SEWAGE DISPOSAL SYSTEM

MARYLAND STATE DEPARTMENT OF HEALTH*

HOWARD COUNTY

SUBDIVISION Evergreen Valley Estates ROAD 3101 Evergreen Way LOT 27, Sec.4

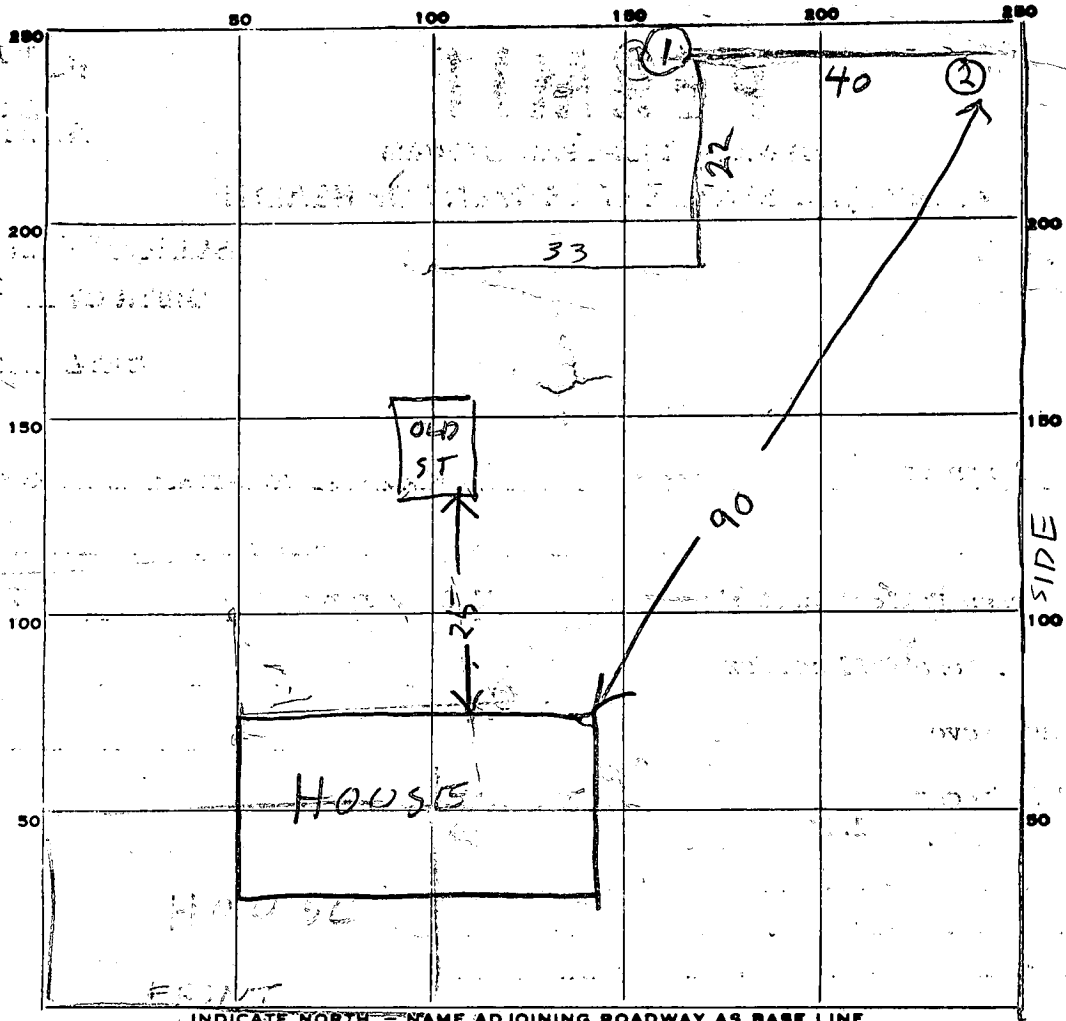
REMARKS 2/19/80 AM TEST HOLE (1) & (2) DUG SOIL POROUS & DRY

2/19/80 - OWNER MEASURED DEPTH OF DITCH ADD A LITTLE

STONE OVER PIPE & ALSO PAPER OVER STONE RH

2/19/80 - MORE STONE ADDED. INSTALL PAPER & COVER RH
